Lower Thames Crossing

9.8 Environmental Statement Addendum (Clean version)

DATE: December 2023
DEADLINE: 10

Planning Inspectorate Scheme Ref: TR010032
Examination Document Ref: TR010032/EXAM/9.8

Contains Ordnance Survey data. © Crown copyright and database rights 2022. Ordnance Survey 100030649

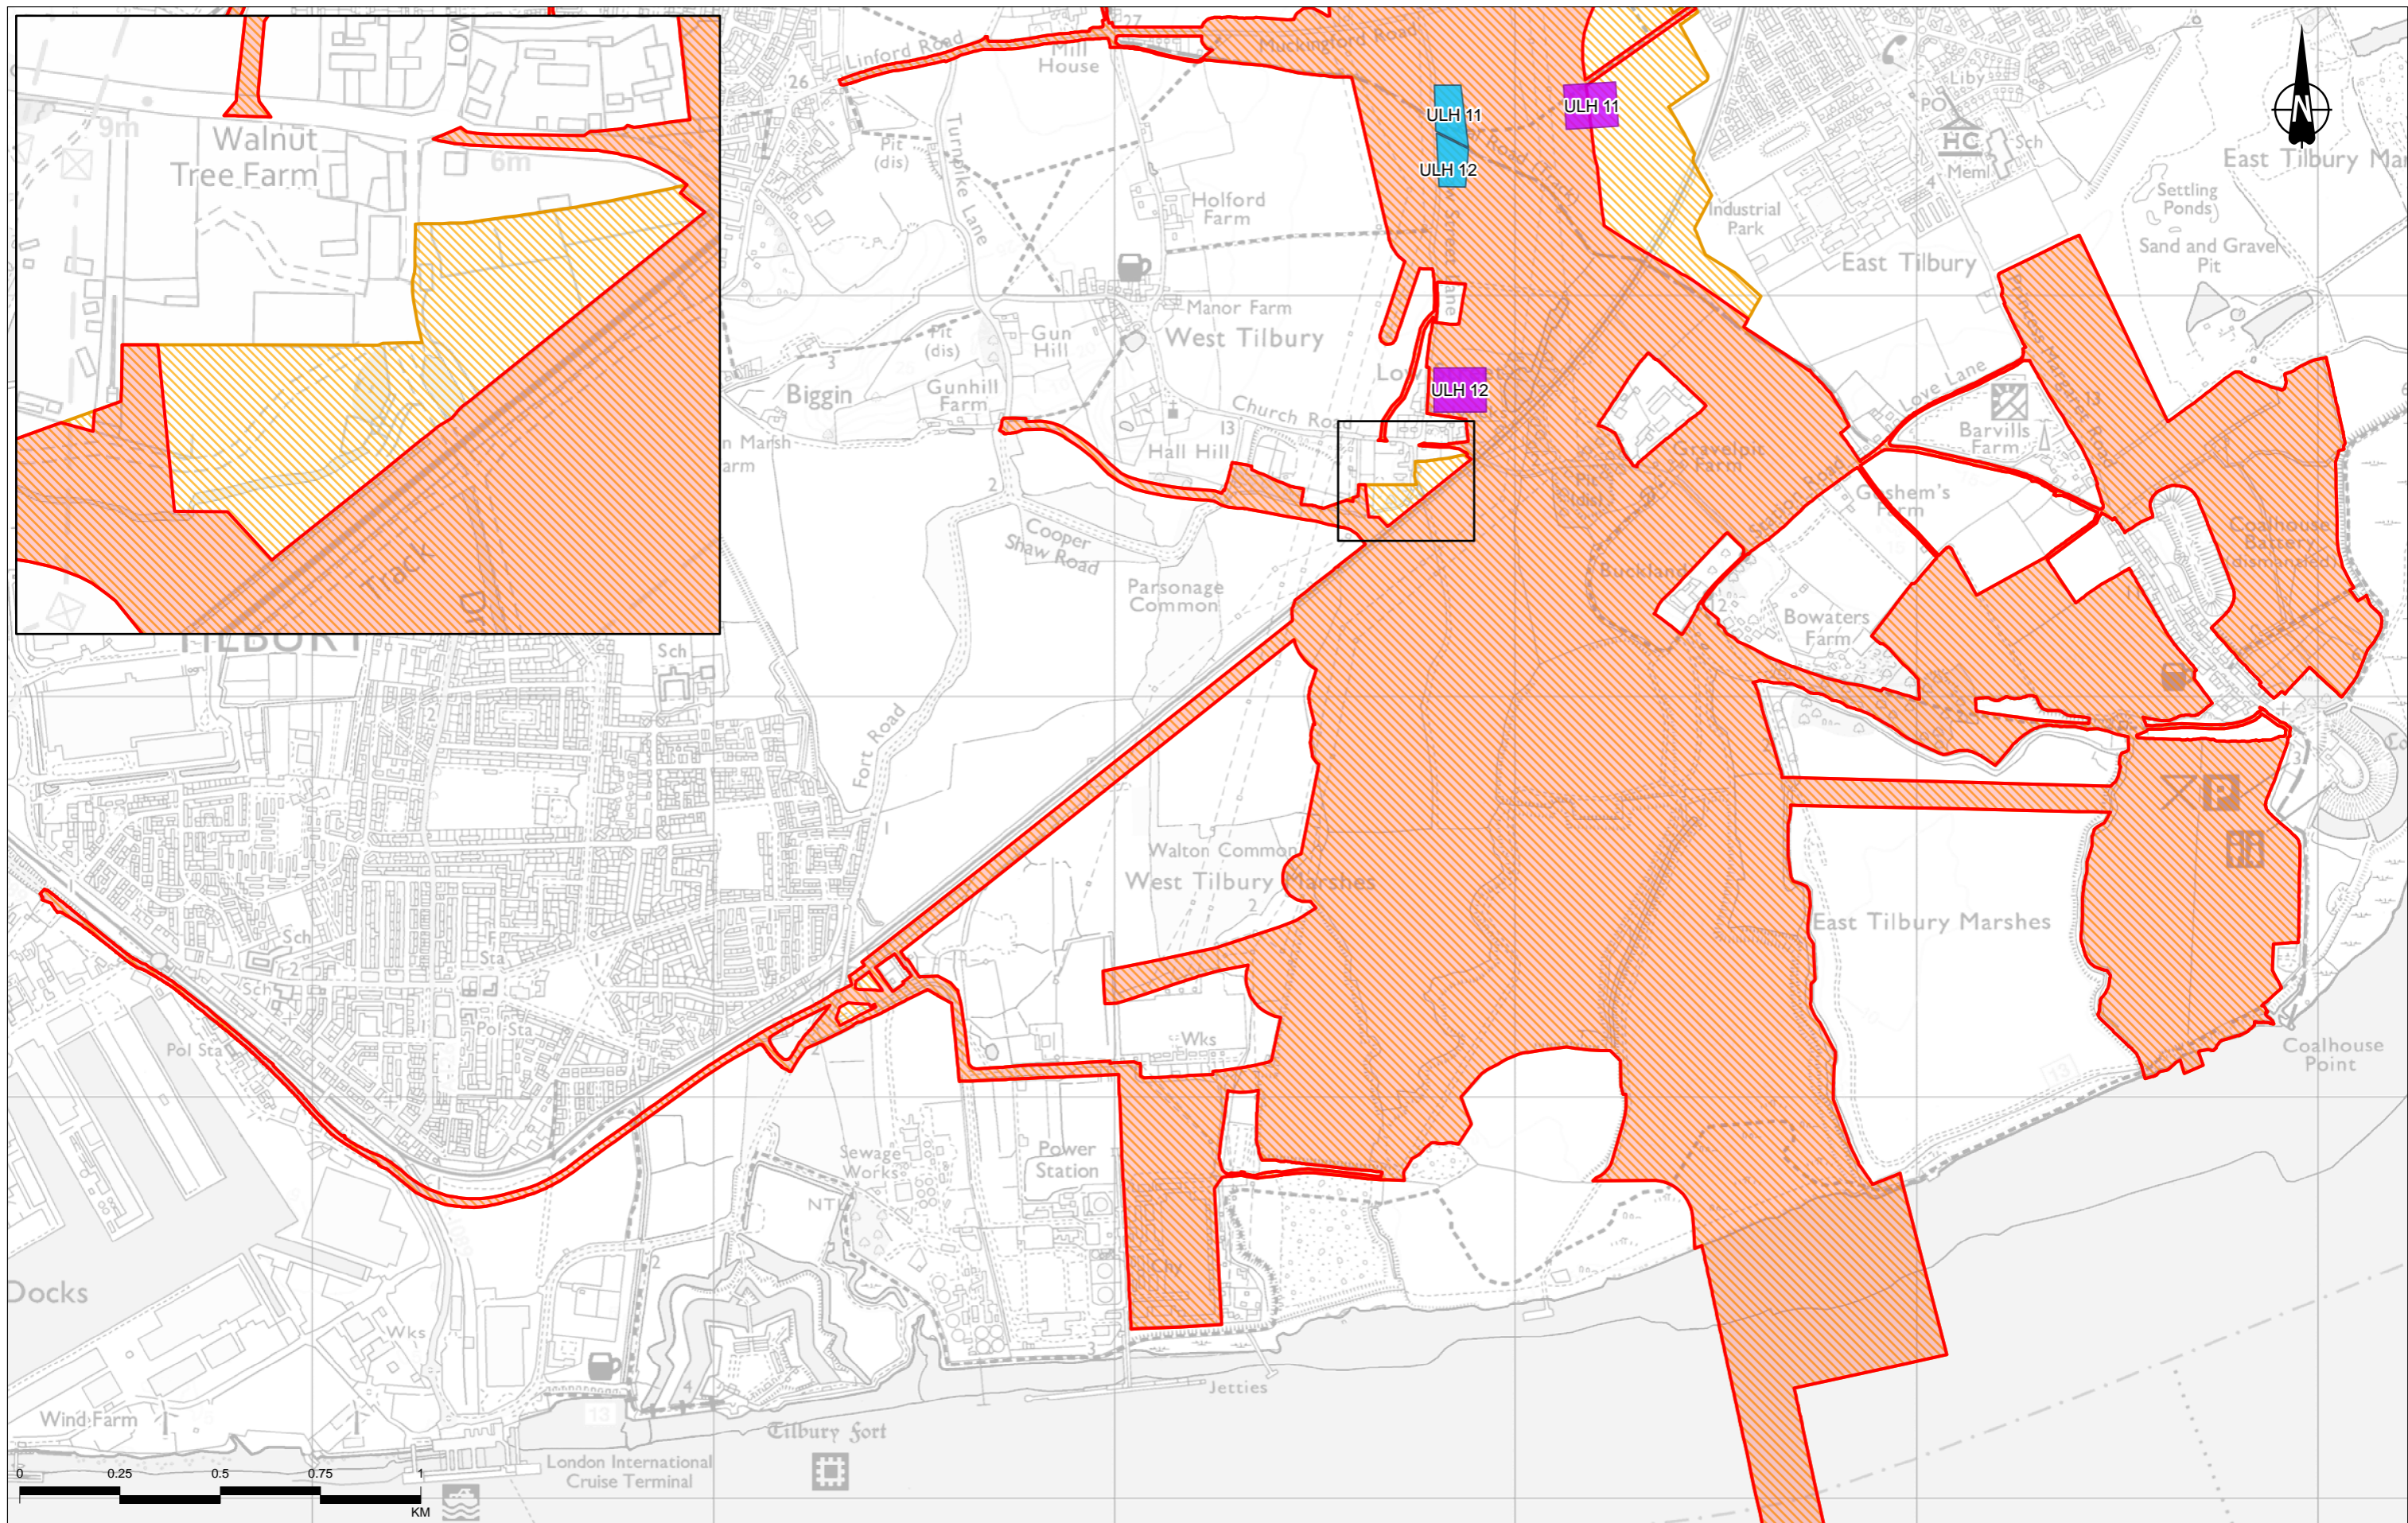
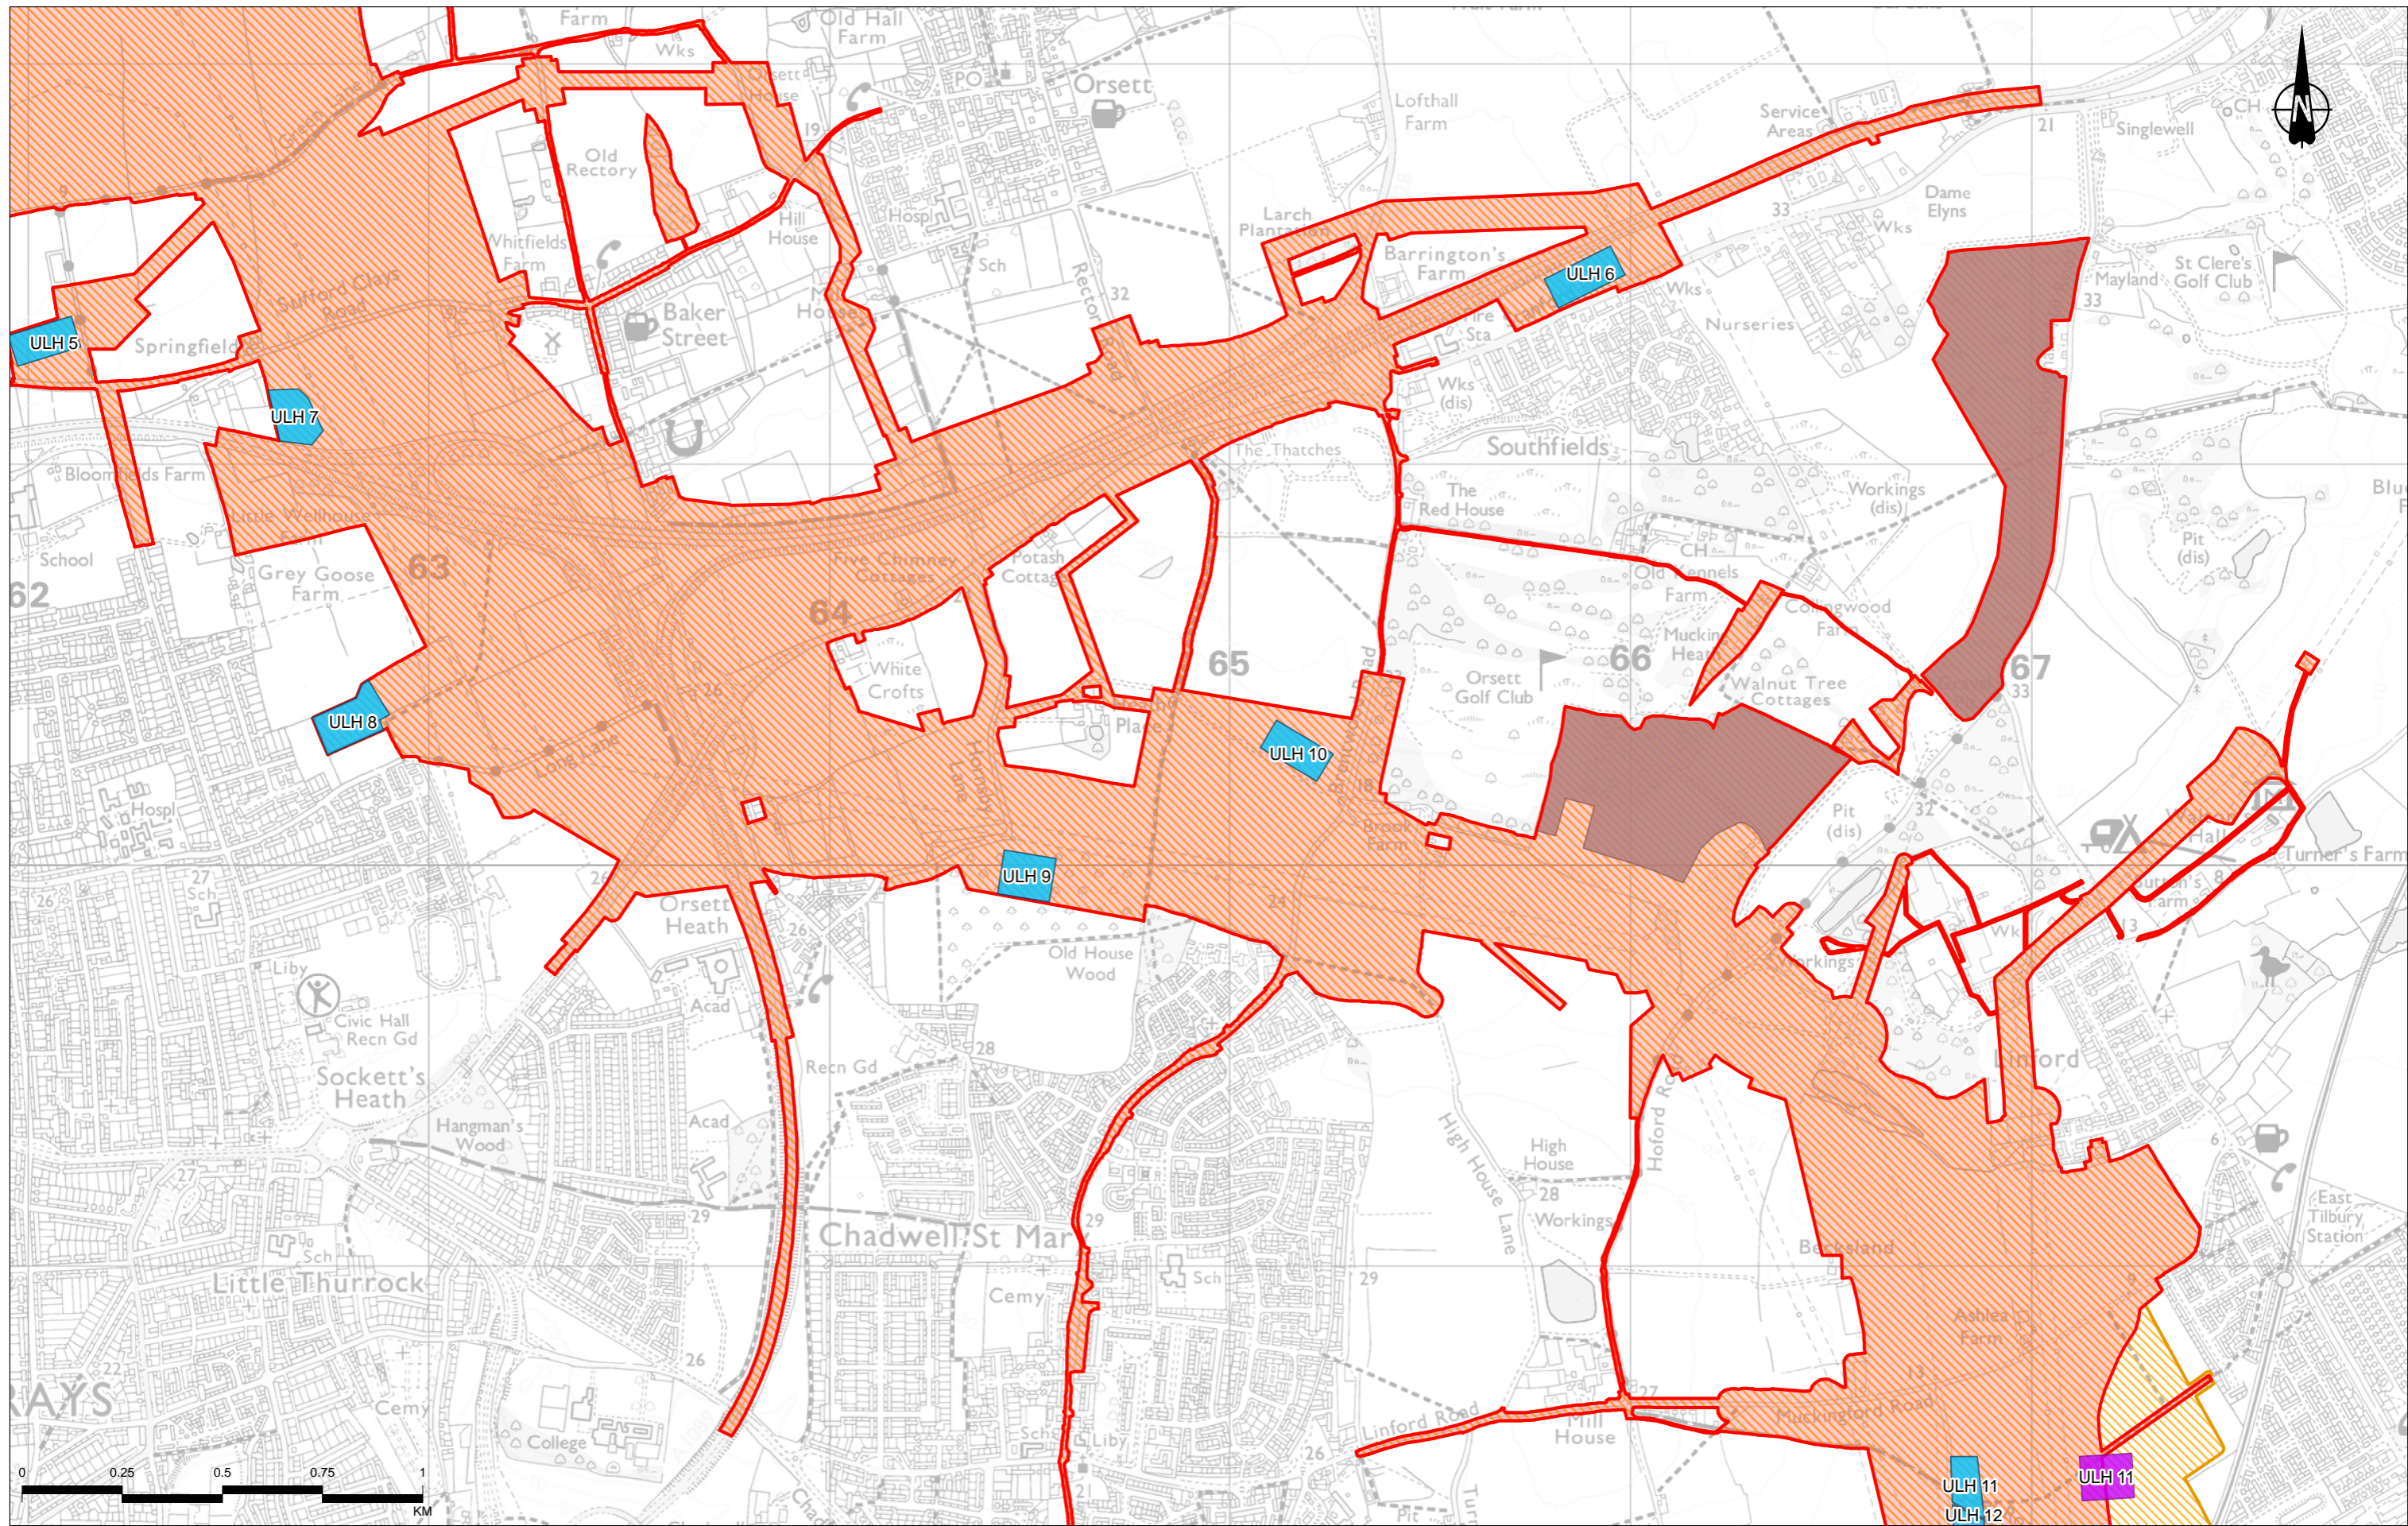
- 1.4.7 Updates to ES documents have been made reflecting changes to Order Limits. Where Order Limits are presented as an important feature supporting the understanding of the figure or plate, these have been shown in a new version of the document and submitted into Examination. Where the Order Limits are considered to be of less importance to the information presented in the figure or plate, for example, providing context to the location shown, these documents are updated via the information presented in this ES Addendum. To aid the understanding of the changes to Order Limits, Figure 1: ES Addendum update to information in figures and plates included in this ES Addendum, shows the original Order Limits as submitted in the DCO application in October 2022 and the final Order Limits as presented at Deadline 9. All figures and plates updated via the ES Addendum should be read with reference to Figure 1.

- 1.4.9 Similar to above, Figure 1 also shows the original and revised locations of the Muckingford Road and Low Street Lane Utility Logistics Hubs (ULH 11 and 12 respectively). As for the above, the record of updates in Section 3 identifies where documents containing this information should be read with reference to Figure 1.
